Agenda Item #: 12

SUB-SW-002553-2023 & MOD-002552-2023

- Waive the construction of a sidewalk along Airport Boulevard
- Modification of a previously approved Planned Unit Development

SIDEWALK WAIVER SITE PLAN

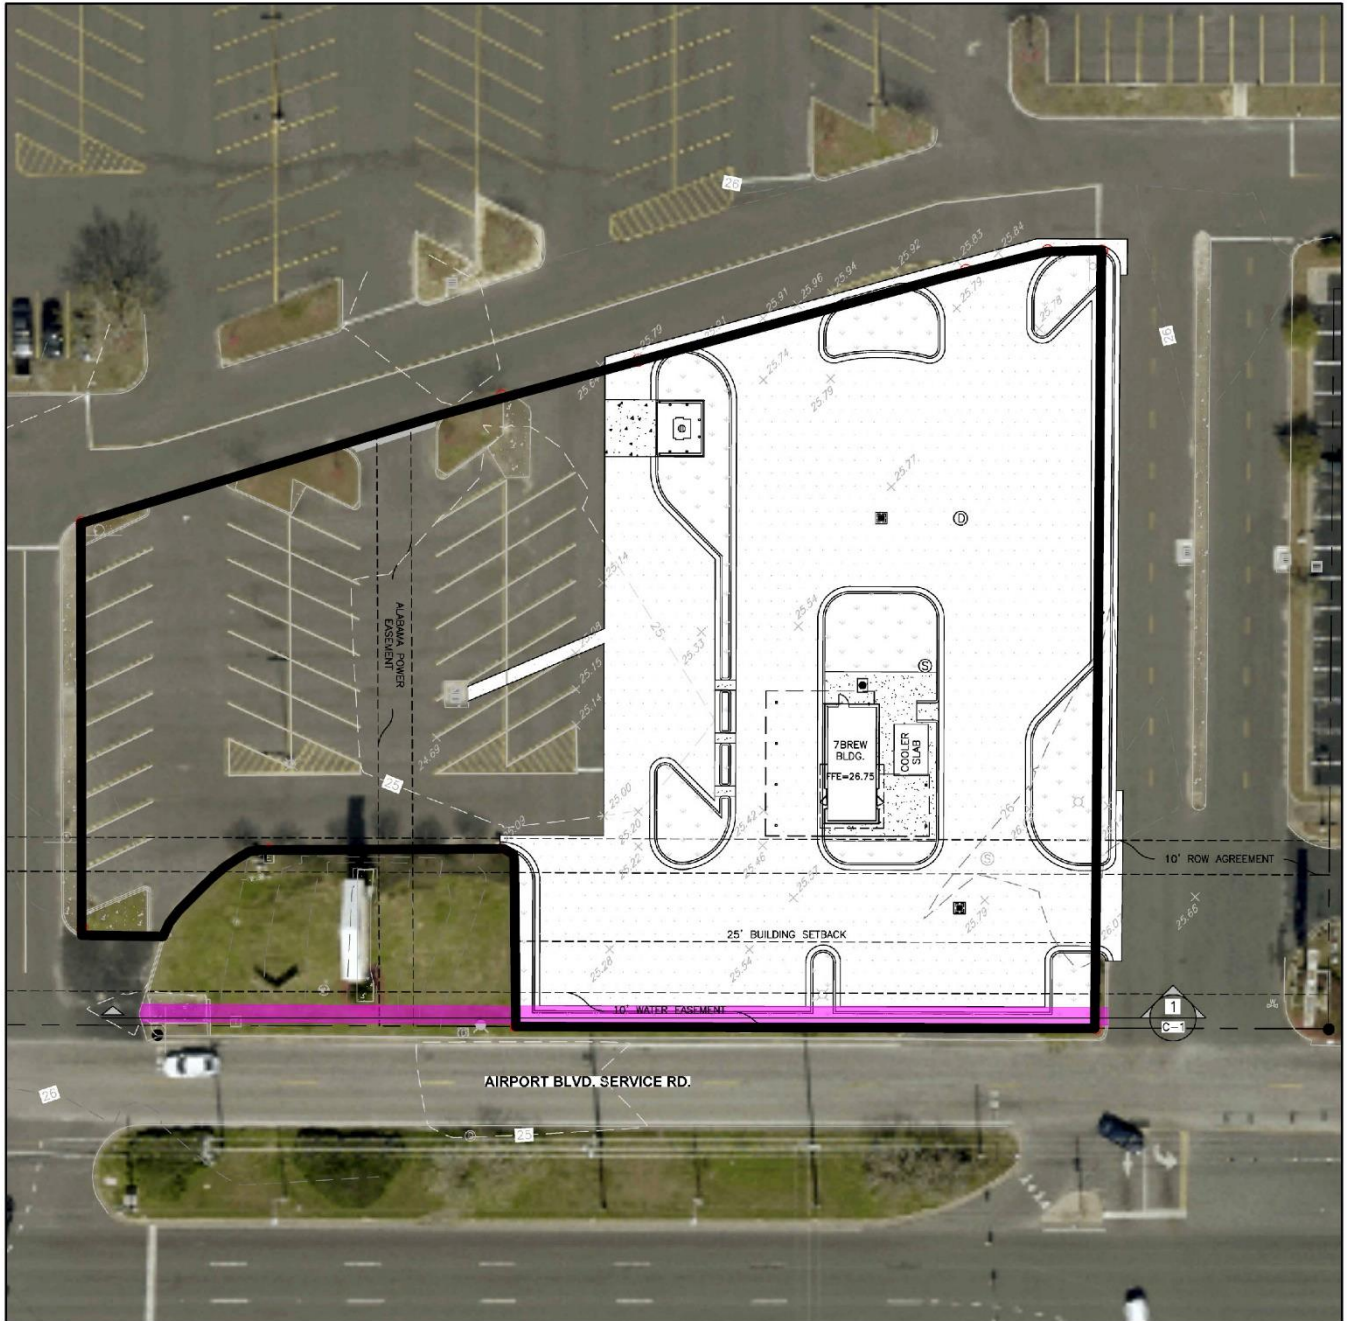
It appears that there is sufficient room within the ROW, or within the property, for the construction of a sidewalk that could be approved through the ROW Permit process.

The subject site consists of Lot 11 of Springdale Mall Subdivision. The applicant proposes to re-develop a portion of the property with a drive-thru coffee shop. Re-development of the site requires a sidewalk to be provided within the public right-of-way. The applicant is requesting to waive construction of a sidewalk along its frontage on Airport Boulevard.

The applicant's comments are available via the link on Page 1 of this report. In summary, the applicant states that the existing mall sign discourages sidewalk installation and that there are no adjoining sidewalks along Airport Boulevard at this location.

The Engineering comments suggest that a sidewalk can be constructed along Airport Boulevard.

PUD SITE PLAN

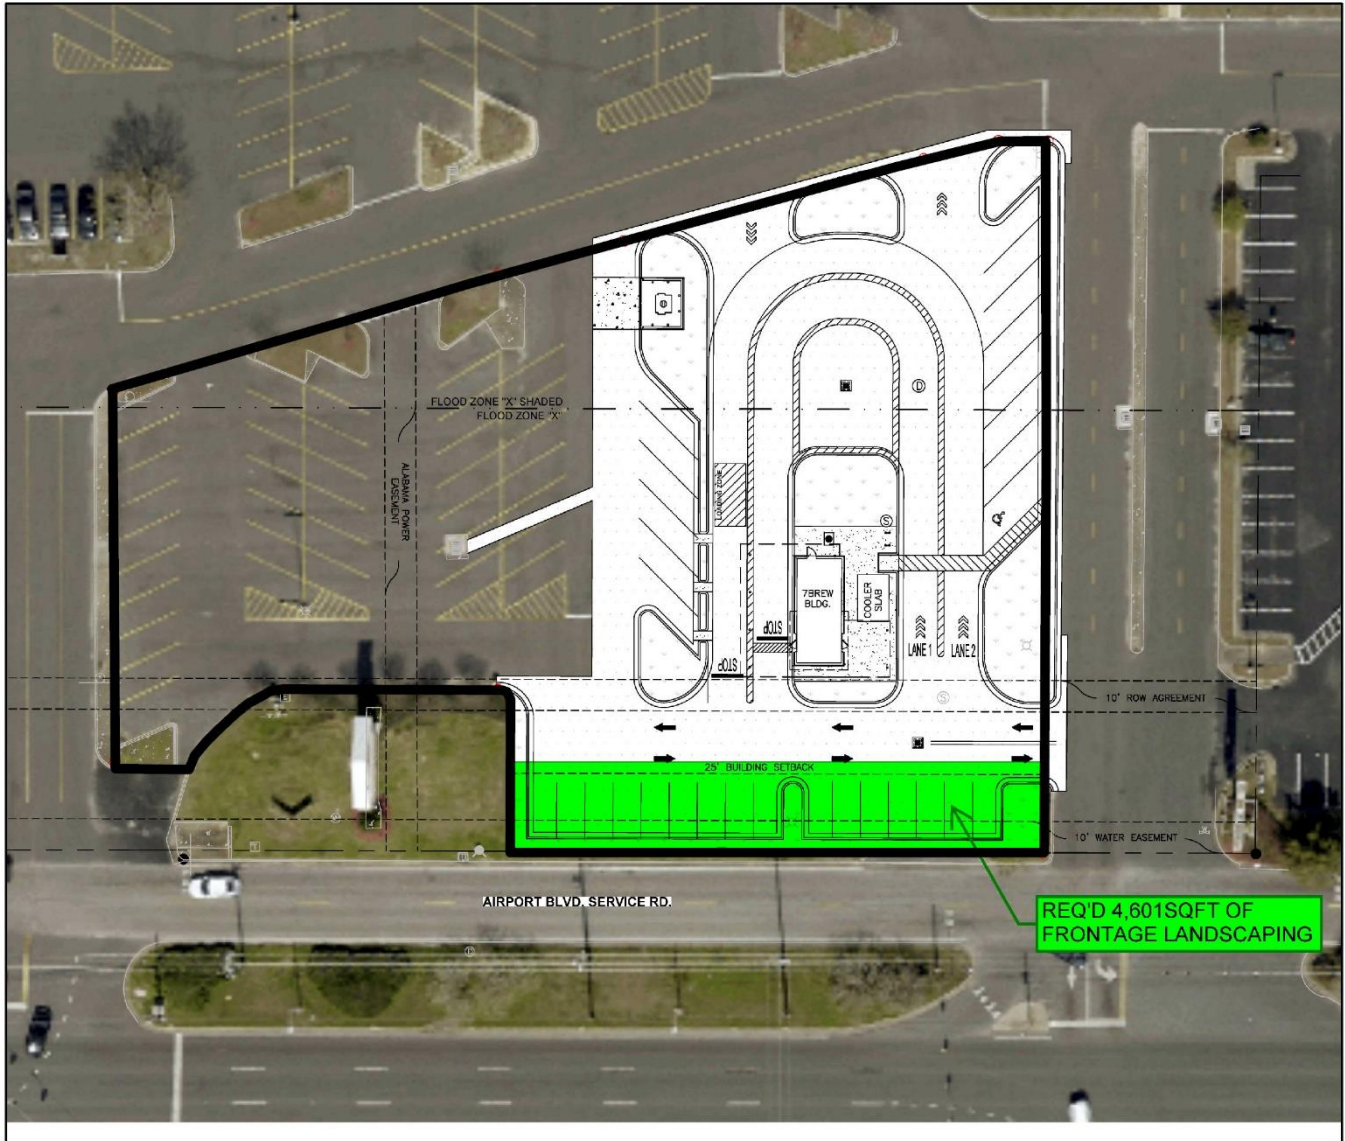
The site plan depicts re-development of a portion of Lot 11 of Springdale Mall Subdivision for use as a drive-thru coffee shop. The site will be accessed through Lot 4 of the subdivision, which surrounds the property. One (1) 510 square-foot building is proposed, along with a canopy, a stand-alone walk-in cooler, a dumpster pad and enclosure, and two (2) drive-thru lanes.

Off-street parking is illustrated, but no required parking calculations are provided. Two (2) parking spaces are required per Table 64-3-12.1 of the Unified Development Code (UDC), and more than enough parking is illustrated; however, a table should be placed on a revised site plan with the amount of required parking and the amount of parking provided. Also, re-development of the site requires the provision of parking lot lighting, which must meet the illumination standards of Section 64-3-9.C. A photometric plan will be required at the time of permitting to verify the site will comply with these requirements.

Two (2) bicycle parking spaces are required and must meet the standards of Section 64-3-12.A.9. Compliance with these requirements should be illustrated on a revised site plan.

Additionally, one (1) small off-street loading space is required per Section 64-3-12.B. and should be illustrated on the revised site plan.

No pedestrian walkway is illustrated connecting the building to a public sidewalk. The site needs to meet the pedestrian walkway requirements of Section 64-3-3 of Article 3 of the UDC, unless the request for a Sidewalk Waiver is approved.

Section 64-2-14.E. of the UDC requires 7,668± square feet (15%) of the site to be landscaped, 4,601± square feet (60%) of which is required to be planted between the street-facing property line and any building wall(s) facing the street. The applicant proposes to plant a total of 5,477 square feet of landscaping, 1,500 square feet of which will be front landscape area (10% of the site, and 32% of the required amount of frontage landscaping). The site is currently paved, with the exception of a few trees. The Planning Commission may consider alternative ways the site could meet the intent of the UDC's landscaping requirements, such as alternative parking lot surfacing, additional tree plantings, etc. If the request is not approved, revision of the site plan will be required to show compliance with the minimum landscape area standards.

Tree plantings are proposed and meet the minimum requirements regarding the number of tree plantings, but the area, dimensional, and canopy standards of Section 64-3-7 for each tree are not illustrated. Furthermore, it's unclear if some trees that are proposed to be planted on adjacent property are being counted toward tree planting requirements for the site. No off-site trees or landscape area can be applied to the site's tree and landscape planting requirements. A tree and landscape area plan will be required at the time of permitting, and it must illustrate compliance with these provisions.

A dumpster pad is illustrated on the site plan, and it appears it will be enclosed. Nevertheless, a note should be placed on the site plan stating any dumpster placed on the property must meet the enclosure and placement standards of Section 64-3-13.A.4. of the UDC.

One (1) 10-foot water and sewer easement is illustrated along Airport Boulevard, and another 10-foot water and sewer easement is illustrated across a portion of the site, parallel to the easement along Airport Boulevard. One (1) of the easements is incorrectly labeled as "10' ROW Agreement," and should be corrected on the revised site

plan. A note should also be placed on the revised site plan stating no structures shall be built in any easement without permission from the easement holder.

1. Provision of the required parking calculations on a revised site plan;
2. Provision of a photometric plan at the time of permitting illustrating parking lot lighting will comply with the illumination standards of Section 64-3-9.C, and provision of a note on the site plan stating that the site will comply with Section 64-3-9.C of the UDC;

3. Revision of the site plan to illustrate compliance with the bicycle parking standards of Section 64-3-12.A.9;
4. Revision of the site plan to illustrate compliance with the off-street facilities standards of Section 64-3-12.B;

5. Revision of the site plan to illustrate compliance with the on-site pedestrian safety standards of Section 64-3-3;
6. Provision of a revised tree and landscape plan at the time of permitting illustrating compliance with the City Council's decision, or in compliance with Section 64-3-7;

7. Provision of a note on the site plan stating any dumpster placed on the property must meet the enclosure and placement standards of Section 64-3-13.A.4. of the UDC;

8. Revision of the site plan to correct the label for the water and sewer easement;

9. Provision of a note on the site plan stating no structures shall be constructed in any easement without permission from the easement holder;
10. Provision of a note on the site plan stating future development or development of the site may require additional modification of the PUD to be reviewed by the Planning Commission and City Council;
